Village/Town of Mount Kisco Building Department
104 Main Street
Mount Kisco, New York 10549
Ph. (914) 864-0019-fax (914) 864-1085

M E M O R A N D U M

SUBJECT: 40 Grove Barn, LLC– 40 Grove Street
Site Plan Application

DATE: May 5, 2023

1 SOUTH ELEVATION
 SCALE: 1" = 10'-0"
 (IN FEET) 1 inch = 10 ft.

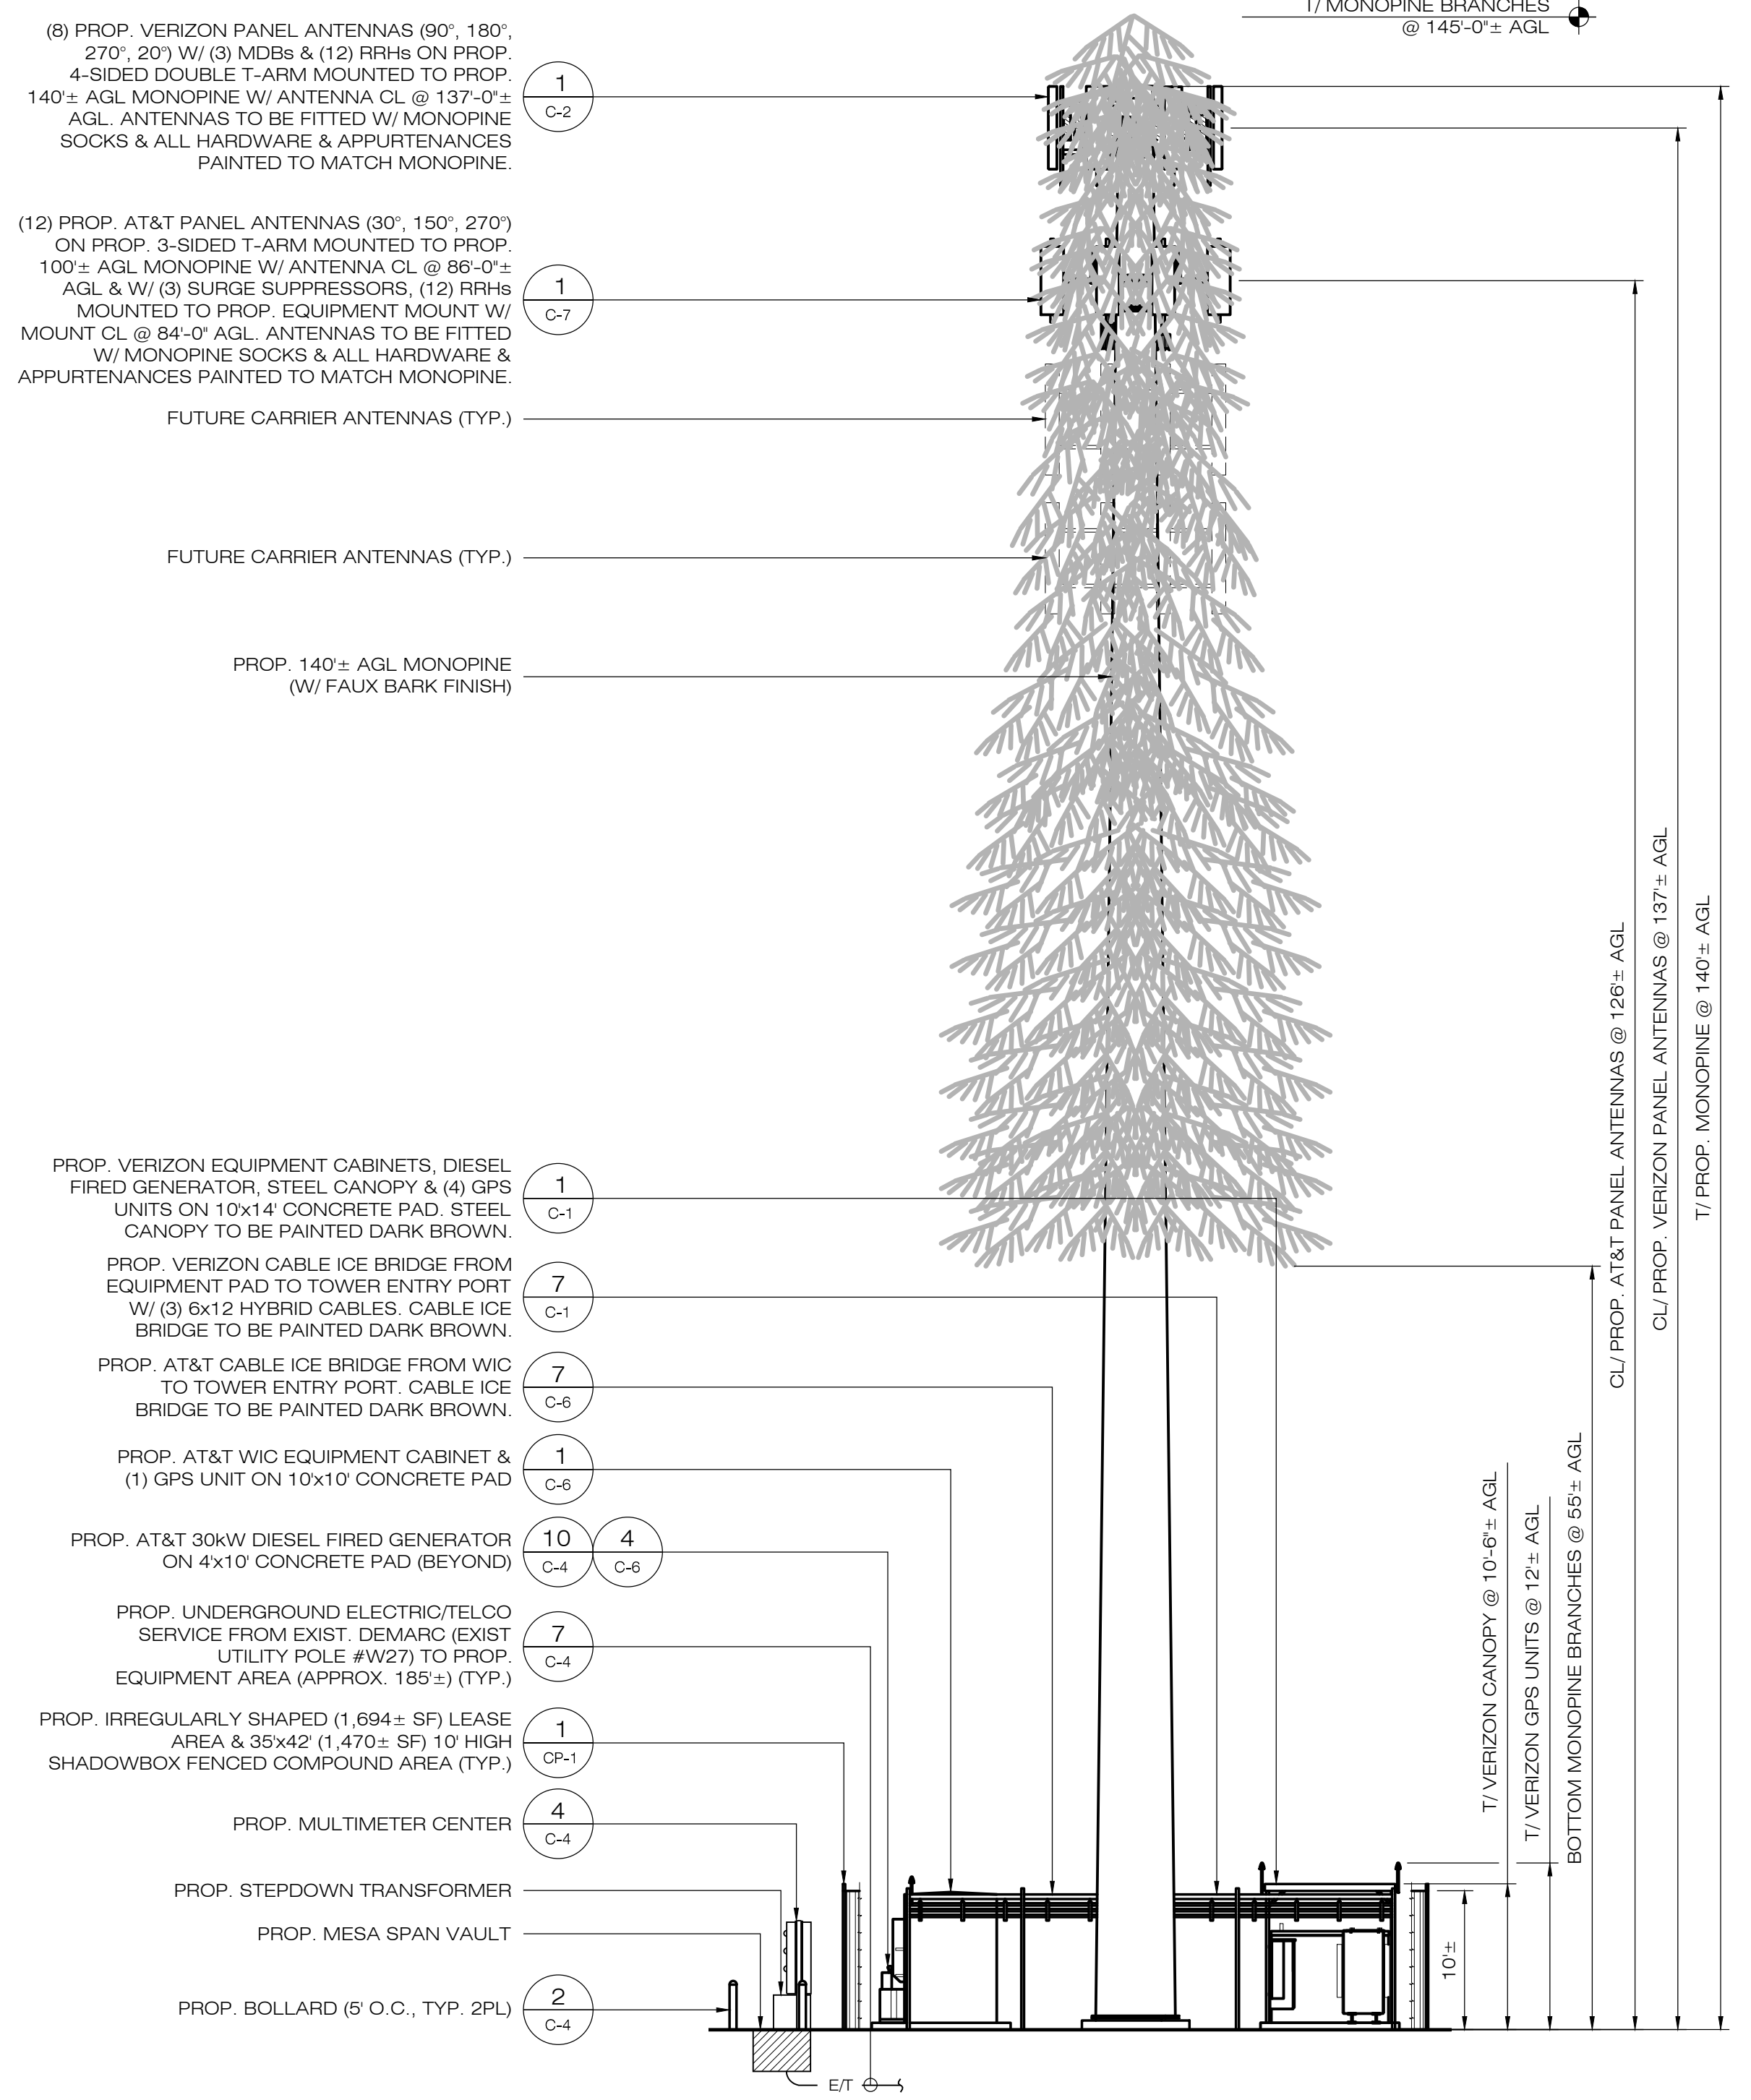
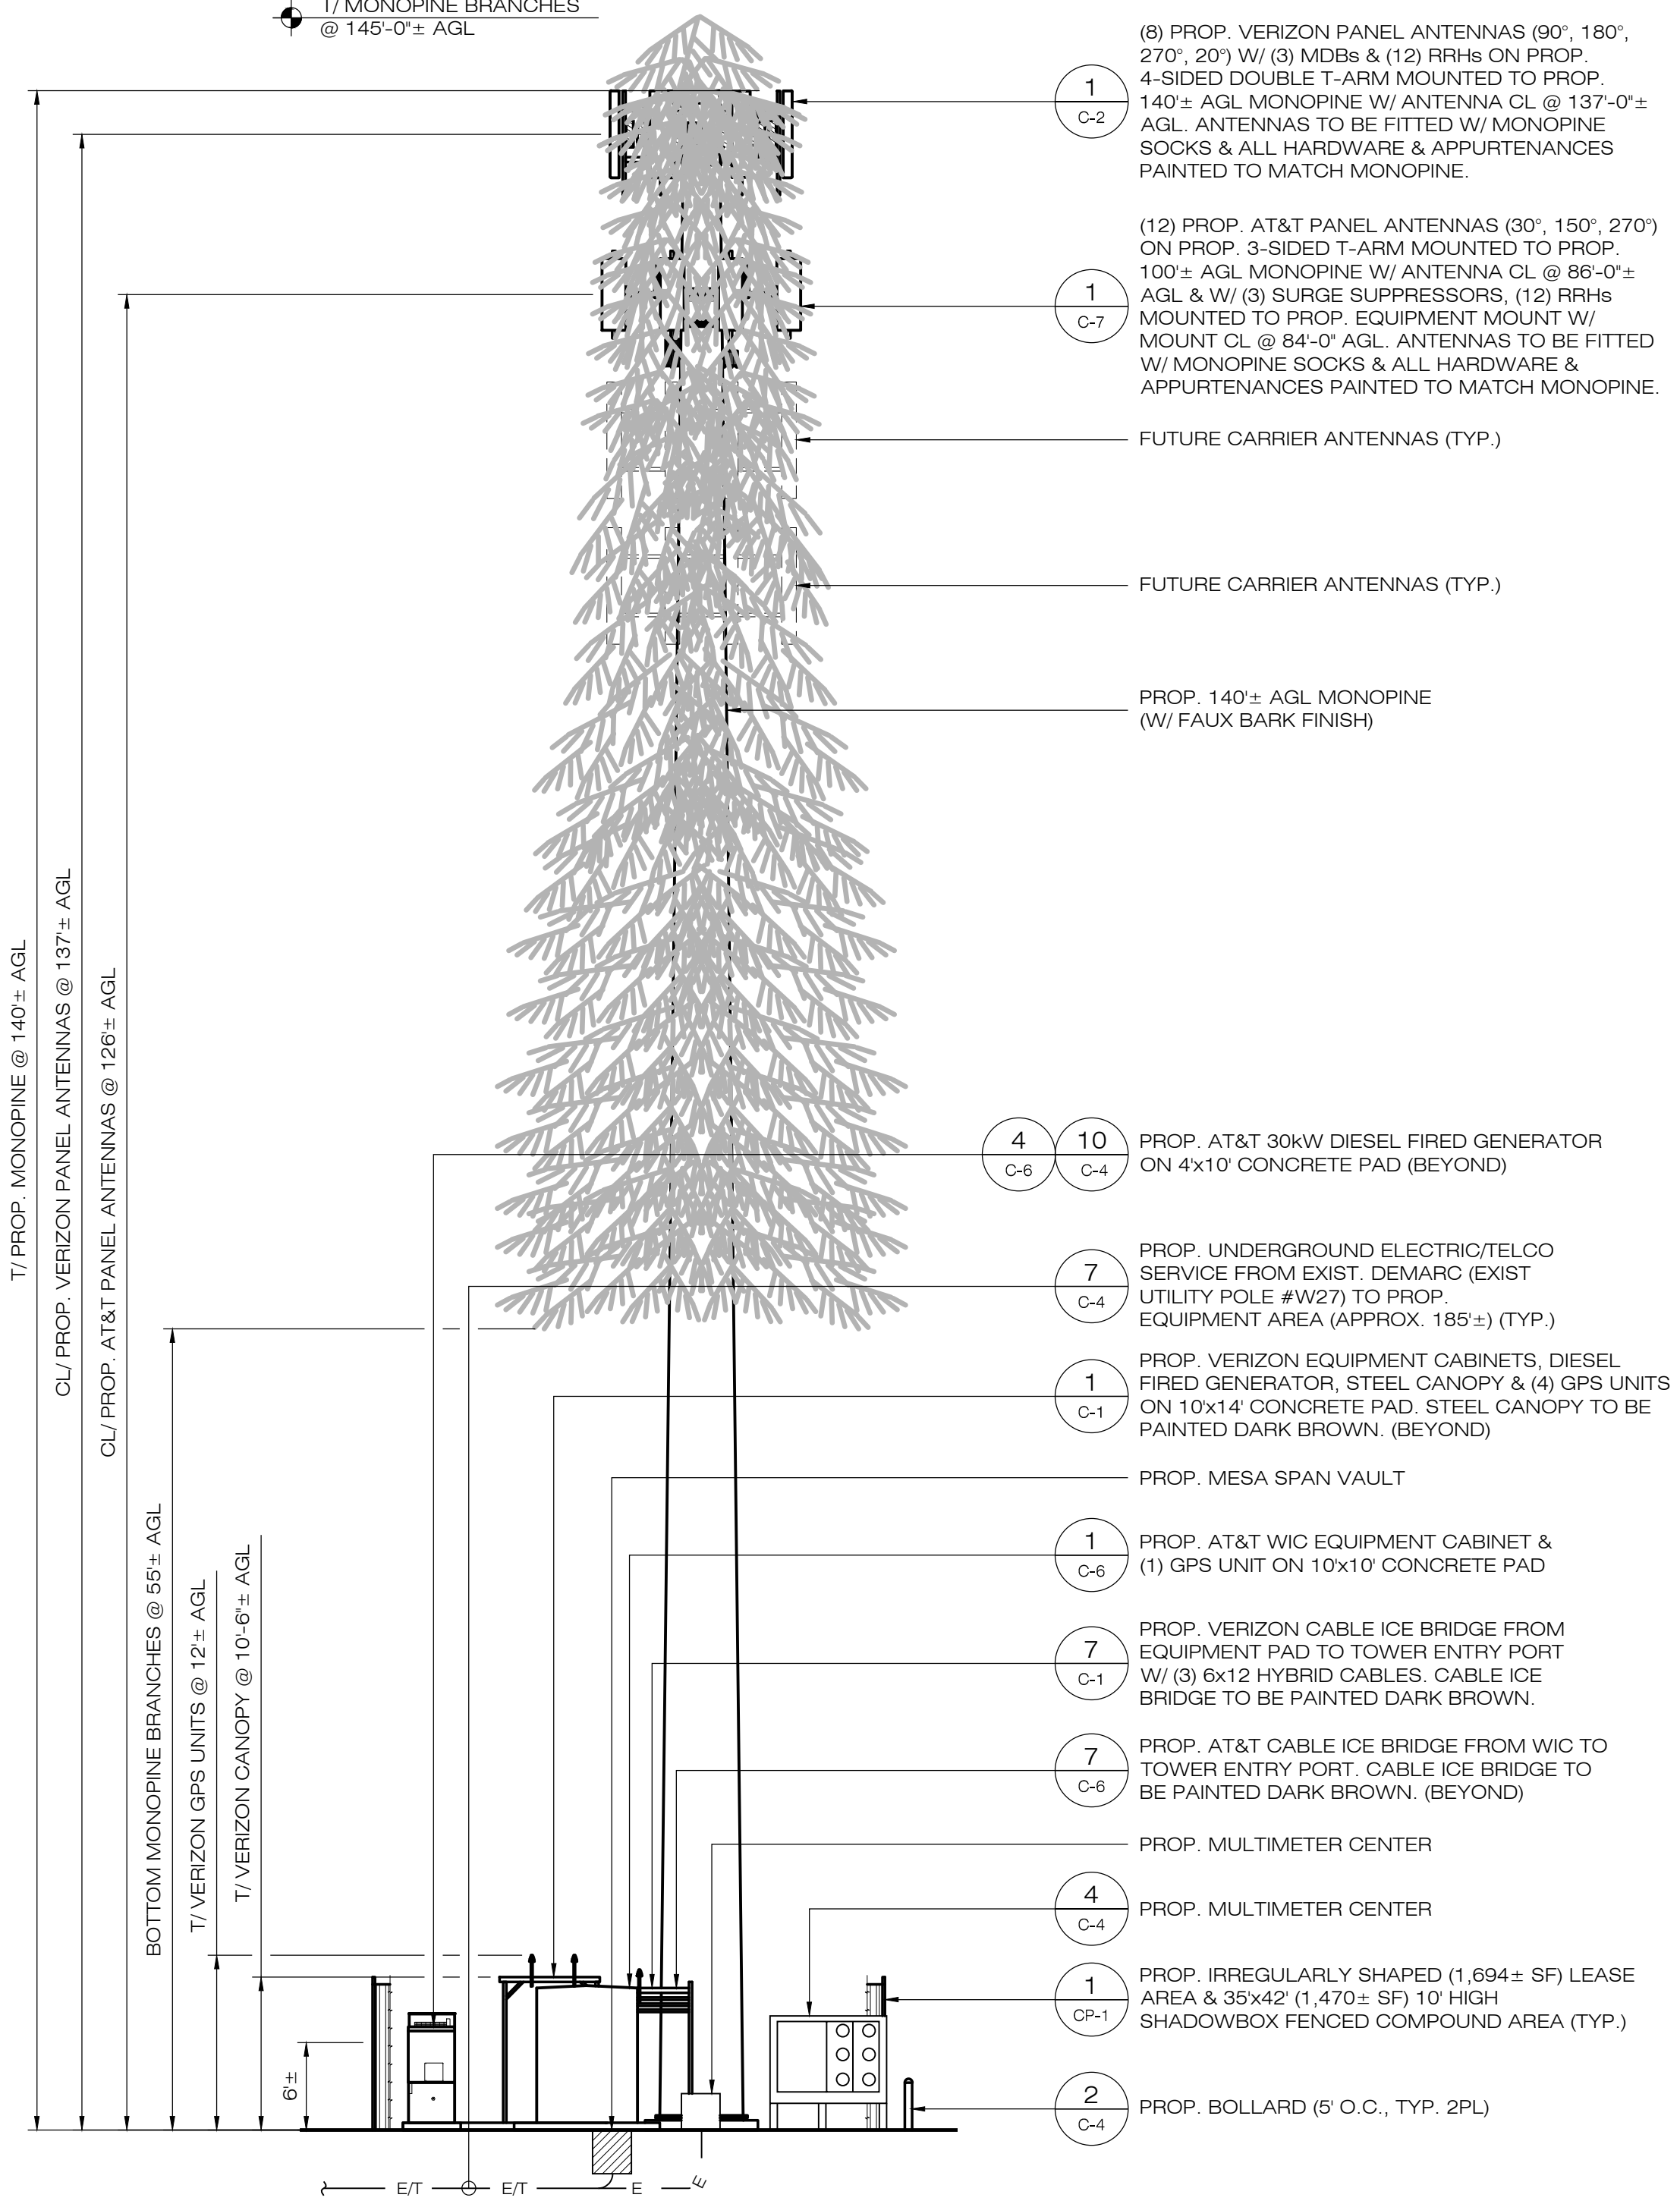
A Tree Preservation Plan has been prepared and is included in the revised Drawing set (Drawings L1 and L2).
- Design criteria of branch density, taper of branches, and maximum feasible extension of branching downward toward the base of the monopole should be implemented. The density of branches shall be at a minimum of three branches per foot. The Site Plan Drawings now show branching extending from 5 ft above the top of the monopole (145 ft above grade level [agl]) down to 70 ft agl; it is recommended that the design extend the branching further downward to 55 ft agl.

- Import notes from On-Site Mitigation Concept #2 (Monopole Design) from the mitigation memo (tree branch density and taper; antenna covers; textures / faux bark; colors and finishes). Evaluate downward extension of branching per mitigation memo.
The notes from On-Site Mitigation Concept #2 have been added to Drawings A-1 and A-2.

A note addressing the branch density of (3) branches per foot has been added to the Drawing A-1 & A-2. The Tower elevations have been revised to extend the monopine branches from 70' AGL to 55' AGL (Drawing A-1 & A-2).
- Monopole texture / color. Faux bark (brown, matte finish) shall be applied to the monopole exterior from grade level to the top of the monopole (entire structure).

The Drawings have been revised to specify a faux bark finish to the proposed monopine (see Drawings A-1 and A-2).
- Antenna covers (“socks”) are proposed and shown in the photosimulations. The antenna covers shall conform to the colors of the stealth tree branching. All visible portions of tower-mounted equipment (cabling, RRH units, distribution box and over-voltage protectors) shall be painted brown (matte finish) as possible to match the monopole color/texture.
